# QorIQ LS1046A Reference Design Board

## Errata

This document lists and describes all known errata for the LS1046ARDB. It also provides available workaround with detailed explanation, wherever required, for each erratum.

Figure 1. E-00001 workaround

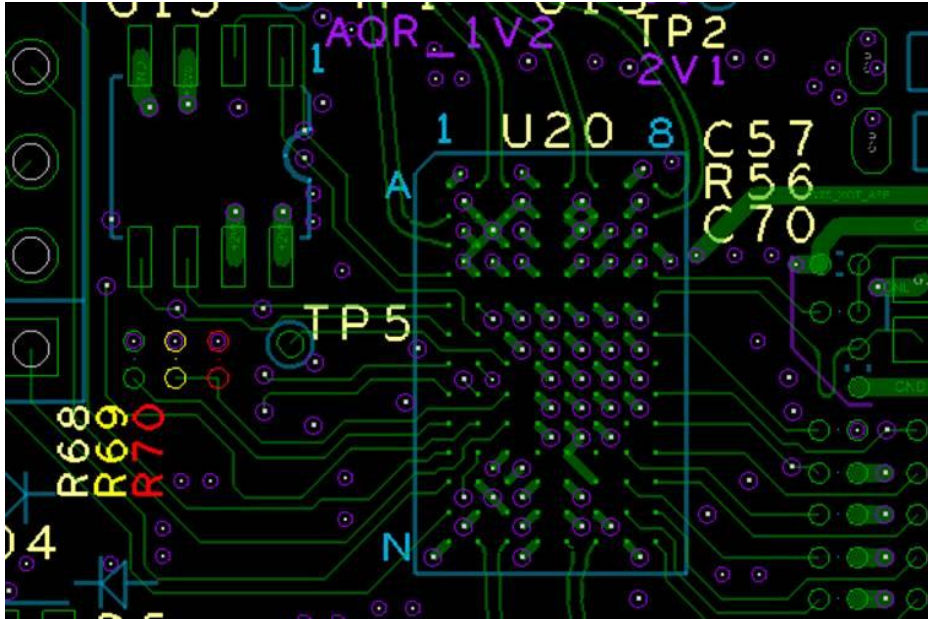
**Description:** As per AQR107-ES2 revision A0, the polarity of MDIO\_1P2\_SELECT\_N is inverted as follows:

- When pulled low, the voltage level is 1.8 V - 2.1 V
- When pulled high, the voltage level is 2.5 V - 3.3 V

**Impact:** AQR107 firmware cannot be programmed and MDIO cannot work.

**Workaround:** Remove R70 (0  $\Omega$ ) and populate R69 (4.99 K $\Omega$ ).

**Fix plan:** The above mentioned rework has been implemented on all revision B boards. Starting board revision B1, no rework is needed.

Figure 2. Rework demonstrated on PCB layout

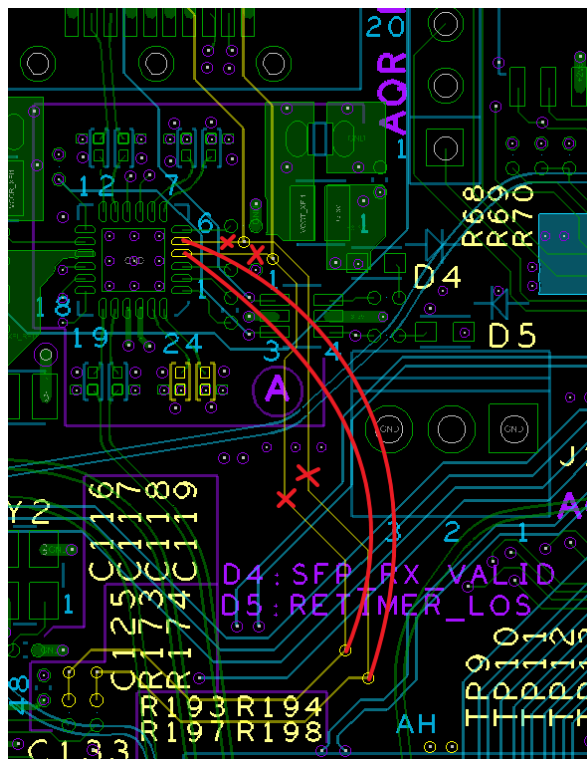
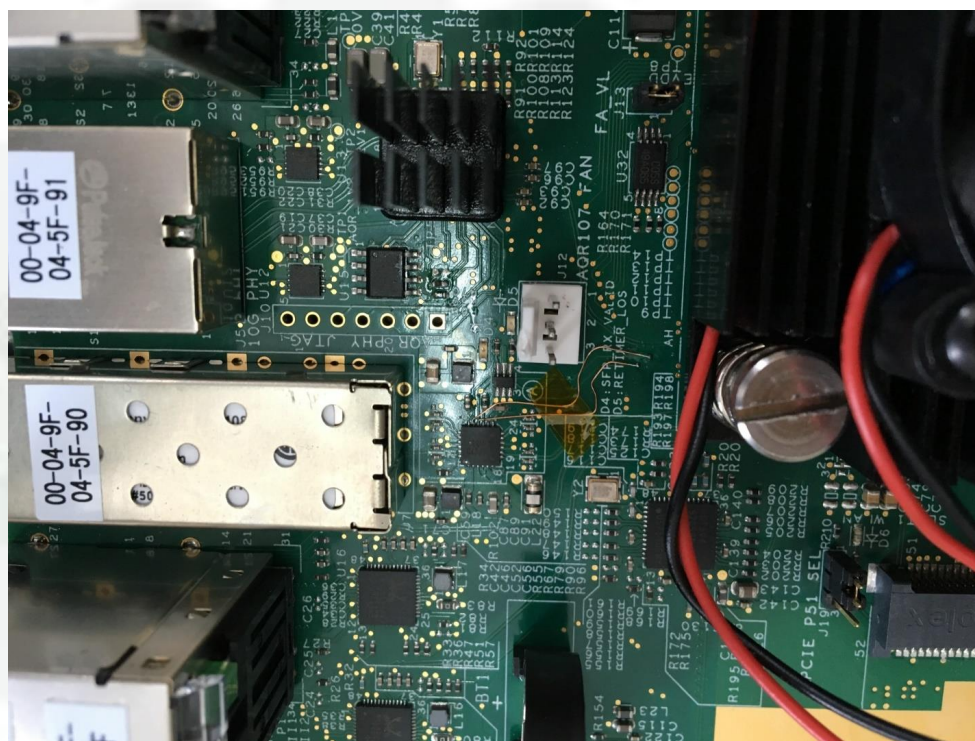
**Description:** When SFP+ module is inserted into the LS1046ARDB, then an I2C address conflict happens between SFP+ module and SPD.

**Impact:** Board stops booting if SFP+ module is inserted.

After the rework, SFP+ module cannot be accessed through I2C1.

1. Cut off top layer trace I2C1\_SDA and I2C1\_SCL before and after vertical interconnect access (via) (1900.60 4402.20) and via (1947.42 4375.42).
2. Fly wire from via (2100.20 3702.90) to pin 5 of U22.
3. Fly wire from via (2065.00 3748.60) to pin 4 of U22.

**Fix plan:** The above mentioned rework needs to be implemented on all revision B boards. Starting board revision B1, no rework is needed. On the PCB Gerber file, I2C connection is disconnected from the SFP slot.

Figure 4. E-00003 workaround

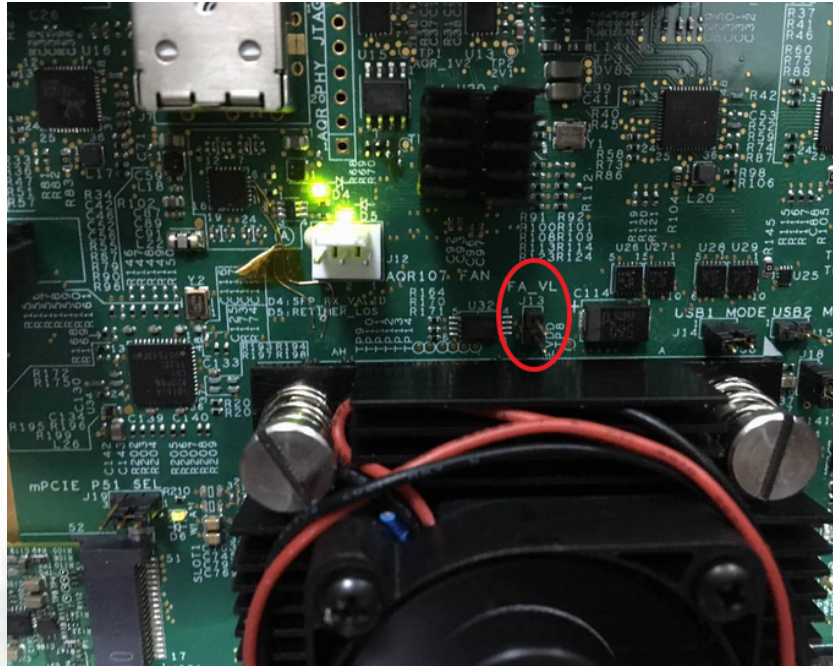
**Description:** The FA\_VL pin has a jumper (J13) to select GND or VDD. On some early-shipped boards, J13 is shorted. The J13 shunt needs to be removed to select GND.

**Impact:** This may impact Linux kernel stability.

**Workaround:** Remove the J13 shunt.

**Fix plan:** The J13 shunt must be removed from all boards with revision B or later.
